Keystone RV Company

SERVICE ADVISORY # 25-461

Coleman Cooktop

**Fig. 3****WARRANTY REIMBURSEMENT****INSPECTION ONLY**

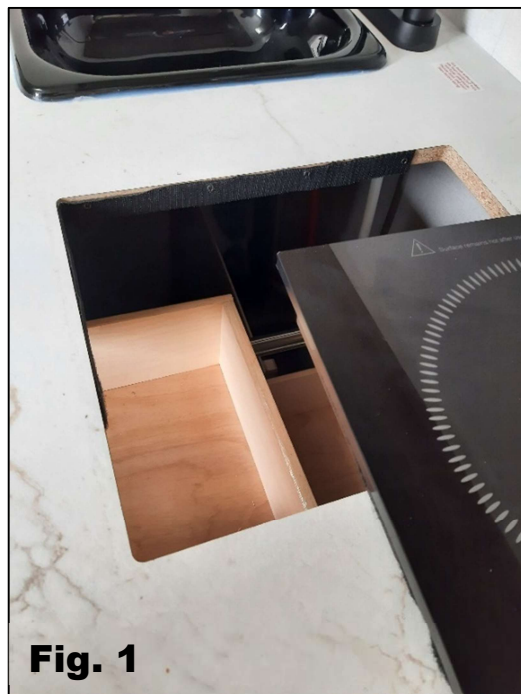
If repair is needed, install missing Velcro in cooktop opening with staple gun, attaching staples linear in fashion as shown in Figure 3.

Utilize one continuous Velcro strip that is cut to 24 inches long on the side and along the bottom edge of the cooktop opening. Then add Velcro to cooktop in the same manner using the self-adhesive backing. Then replace the cooktop back into opening being secured by Velcro. Proceed with warranty reimbursement.

The remedy is to install Velcro in the cooktop opening and to the base of cooktop to secure cooktop for travel.
